December 5, 2016
BOARD OF COUNTY COMMISSIONERS
ORANGE COUNTY, FLORIDA
Addendum No. 4, IFB Y17-718-CC
DEPUTY JONATHAN "SCOTT" PINE COMMUNITY PARK

This addendum is hereby incorporated into the bid documents of the project referenced above. The following items are clarifications, corrections, additions, deletions and/or revisions to, and shall take precedence over, the original documents. Underlining indicates additions, deletions are indicated by ~~strikethrough~~.

A101

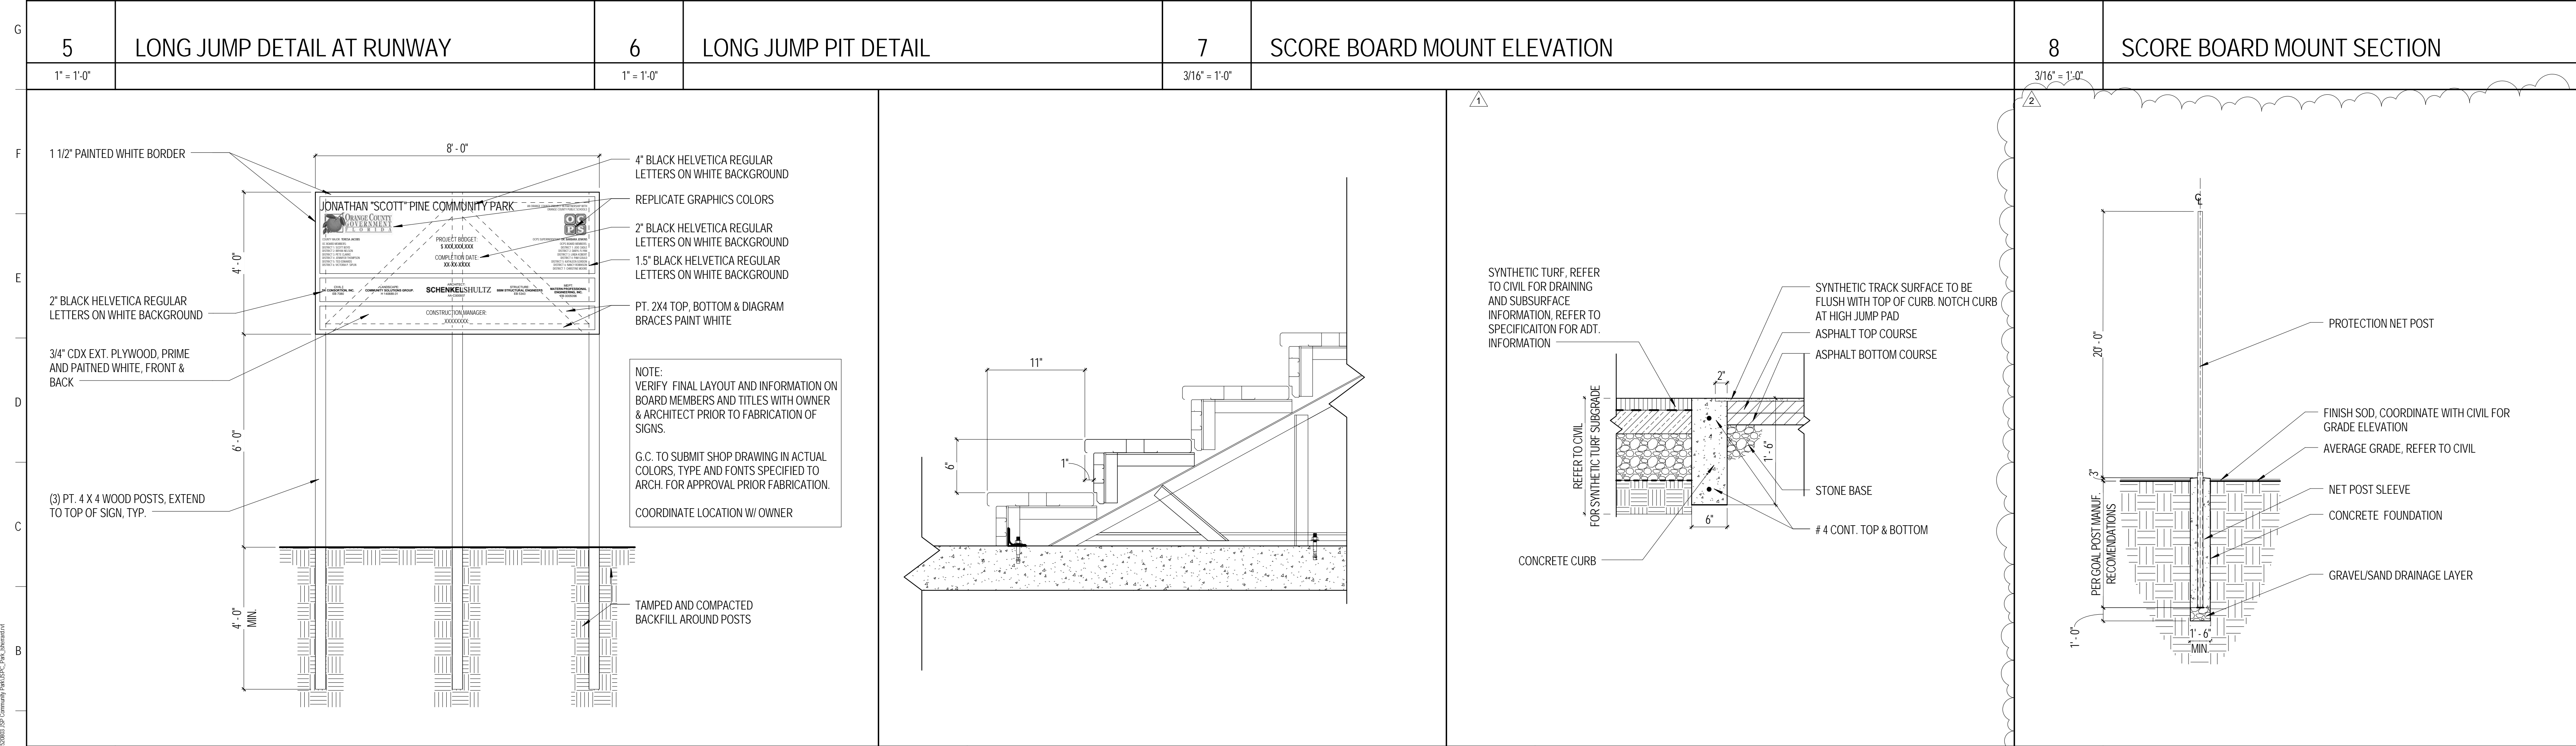
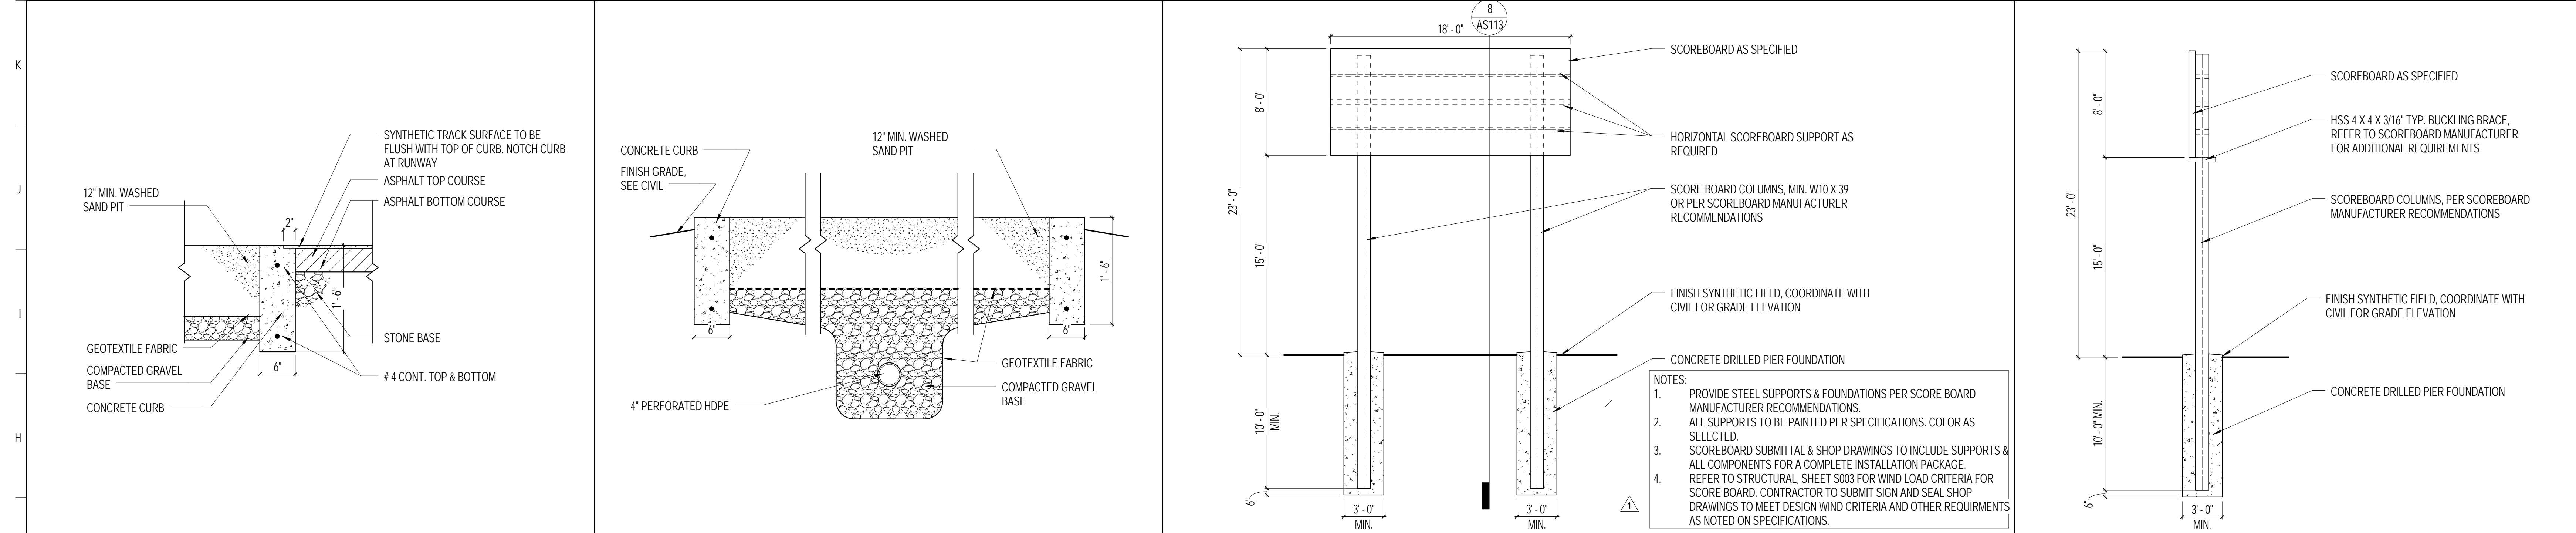
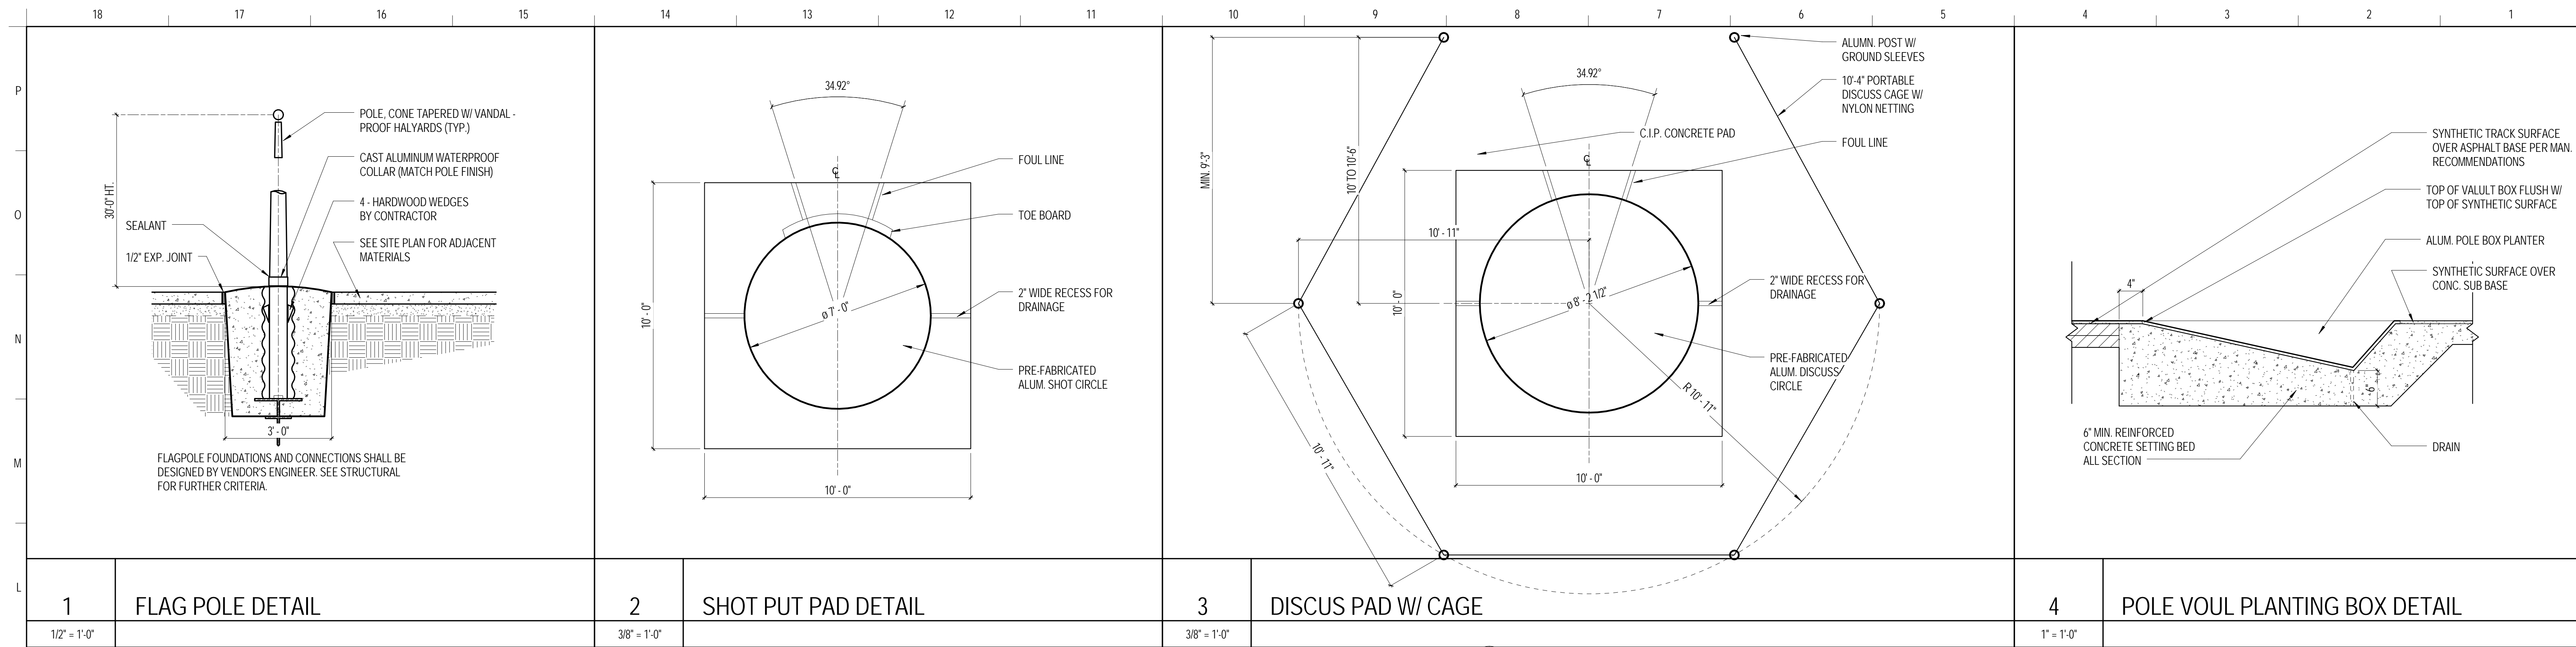
- 2. Revision:** The following drawings have been revised and are attached:
 - a. DRAWING SHEET A101 – OVERALL FLOOR PLAN dated 12/5/16
 - i. Revised layout which includes 48 lockers total in each locker room. Revised layout deletes one CMU chase on the eastern side of each locker room and modifies the CMU chases on the western side of each locker room.

Answer: All athletic lockers are to have HDPE end and top panels as called for in the specifications and no sloped tops. Replace specification 10 51 13 in its entirety with the attached specification 10 51 13 dated 12/05/2016. Lockers have changed to 24”W x 22”D x 72”H open front lockers. Refer to attached revised locker room layout for revised layout which includes 48 lockers total in each locker room. Revised layout deletes one CMU chase on the eastern side of each locker room and modifies the CMU chases on the western side of each locker room.

AS113

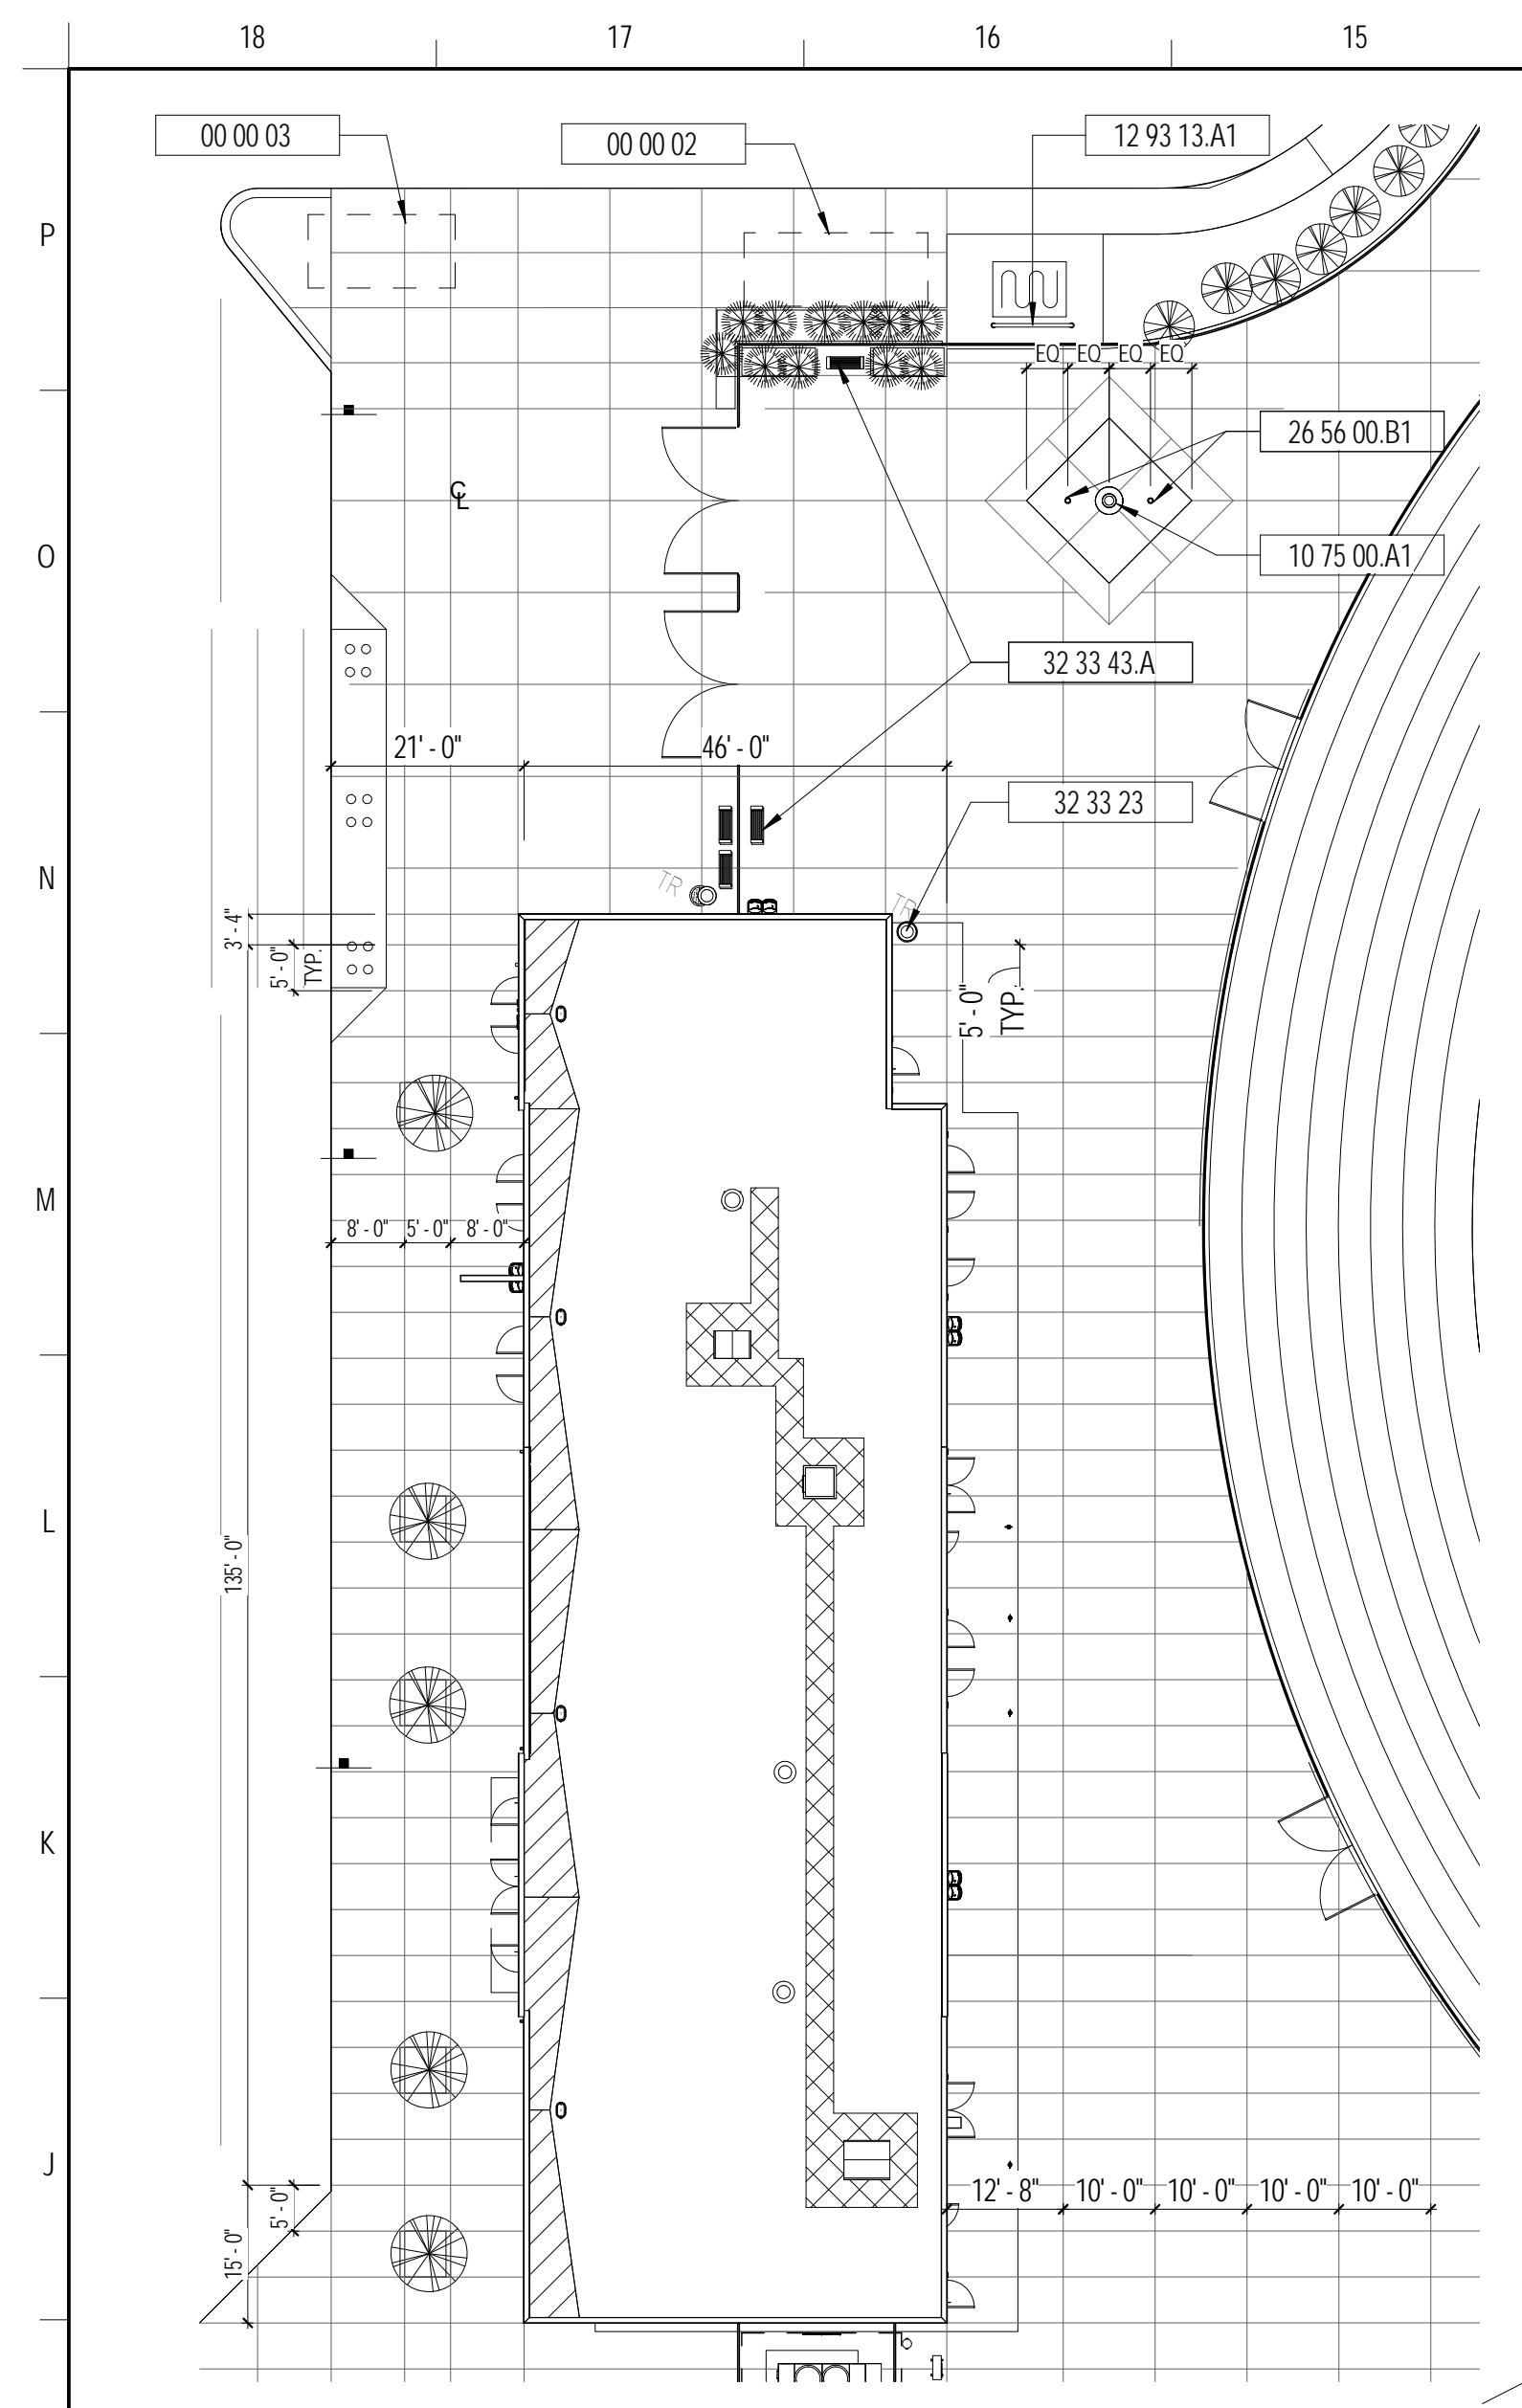
- e. DRAWING SHEET AS113 – SITE DETAILS, dated 12/5/16
 - i. Protection net detail
